Access Compliance Report

Public Rights-of-Way

(Curb Ramps)

Intersection ID: 3512	Main Street: BALATA_CT	Cross Street: SAWGRASS_RIDGE_PL	Location: SW
ADA ID: E479EA86D2EF	Ramp Type: Perp	Initial Pass/Fail: Fail	Overall Compliance: No
		Severity Score: 12.5

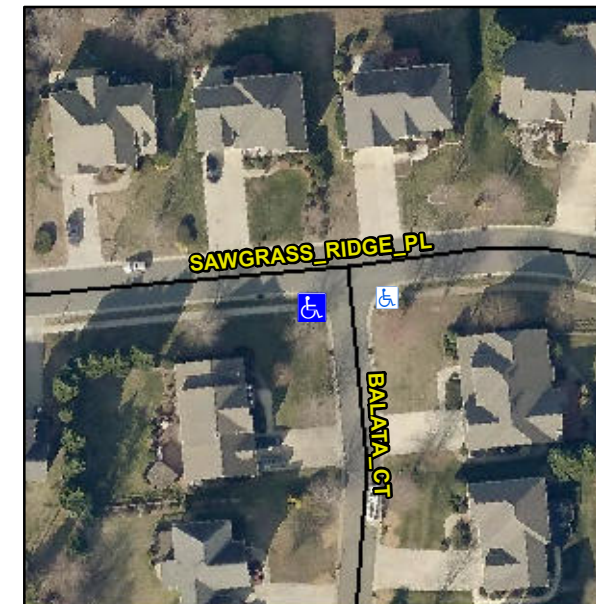
Not Found, R304.2.2

Compliance	Description	Data	Compliance	Description	Data
N/A	Ramp Length (in)	45.0	No	Ramp Slope (%)	8.7
Yes	Ramp Width (in)	58.0	Yes	Ramp XSlope (%)	1.7
N/A	Flare Type LT	N/A	N/A	Flare Type RT	N/A
N/A	Flare Slope LT (%)	N/A	N/A	Flare Slope RT (%)	N/A
N/A	Flare Traversable LT?	N/A	N/A	Flare Traversable RT?	N/A
N/A	Landing Length (in)	N/A	N/A	DWS Provided?	N/A
N/A	Landing Width (in)	N/A	N/A	DWS Contrast?	N/A
N/A	Landing Slope (%)	N/A	N/A	DWS Length (in)	N/A
N/A	Landing X Slope (%)	N/A	N/A	DWS Full Width?	N/A
N/A	Landing Curb? (Y/N)	N/A	N/A	DWS Offset (in)	N/A
N/A	Shared Landing?	N/A			
N/A	Gutter Ponding?	N/A	N/A	Gutter Slope (%)	N/A
N/A	Gutter Lip Ht (in)	N/A	N/A	Gutter X Slope (%)	N/A
N/A	Painted X Walk1?	No	N/A	Painted X Walk2?	N/A
	X Walk 1 Direction	To E		X Walk 2 Direction	N/A
N/A	X Walk 1 Width (in)	N/A	N/A	X Walk 2 Width (in)	N/A
	X Walk 1 Slope (%)	3.5		X Walk 2 Slope (%)	N/A
	X Walk 1 X Slope (%)	1.9		X Walk 2 X Slope (%)	N/A

Remove & Replace Entire Ramp.
